Groundwater Application Review Summary Form

Application # G- 19427

GW Reviewer Darrick E. Boschmann Date Review Completed: 12/11/2024

TO: Water Rights Section Date 12/11/2024
 FROM: Groundwater Section Darrick E. Boschmann
 Reviewer's Name
 SUBJECT: Application G- 19427 Supersedes review of N/A
 Date of Review(s)

G-18918

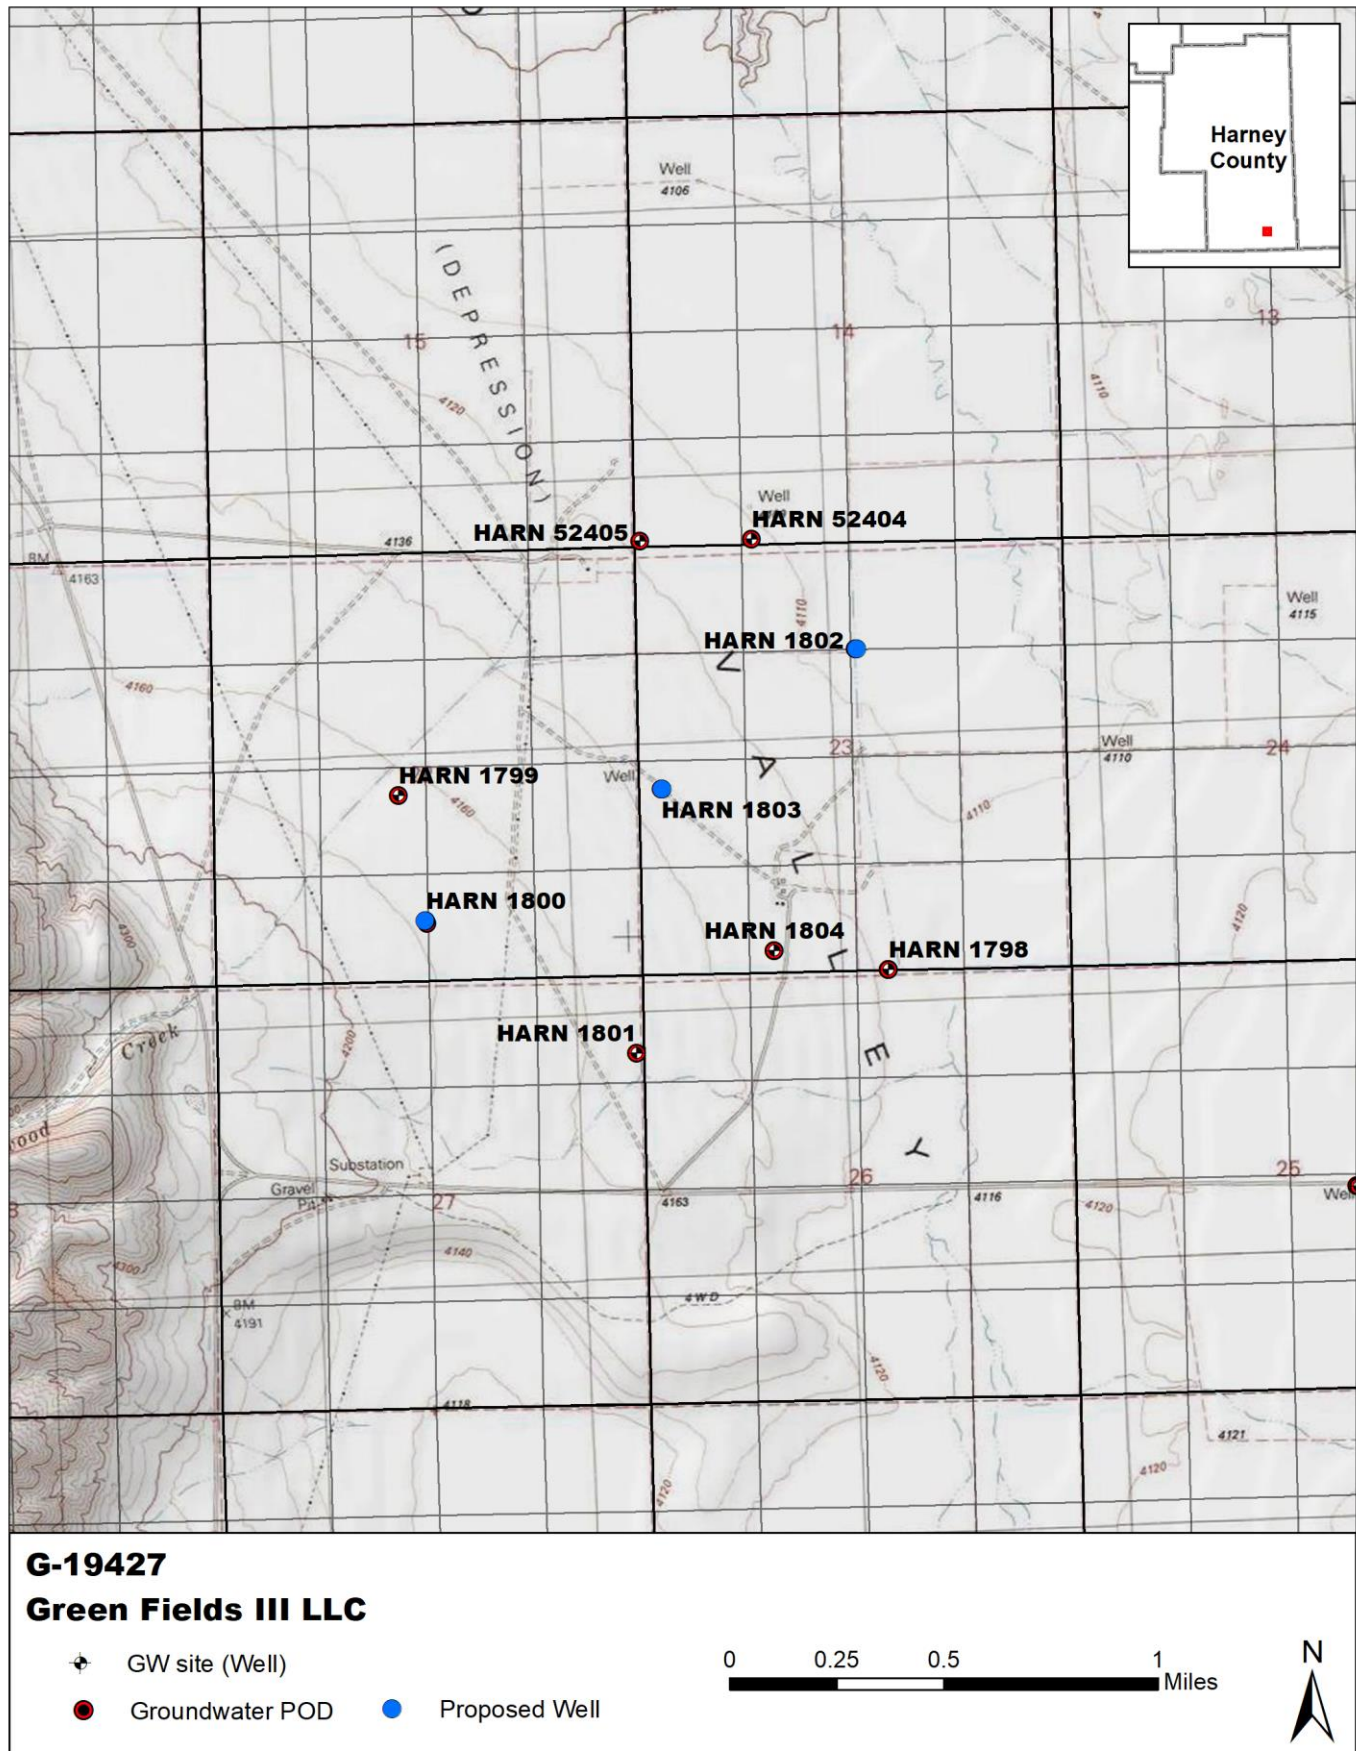
TC3 (HARN 1802) – The well report indicates that the well was constructed with a 16-inch diameter steel casing sealed with concrete in a 20-inch diameter bore hole. Concrete can only be used when the oversized drill hold is a minimum of eight inches larger in diameter than

the well casing used in construction of the well. In addition, the well report also indicates that the 16-inch diameter, 0.25 gage steel casing extends from zero feet above ground surface to a depth of 296 feet below ground surface. To meet minimum well construction standards, the casing must extend a minimum of 1 foot above ground surface and the 16-inch diameter, 0.25 gage steel casing must not exceed a maximum depth of 250 feet below land surface. The annular seal and well casing will need to be properly replaced.
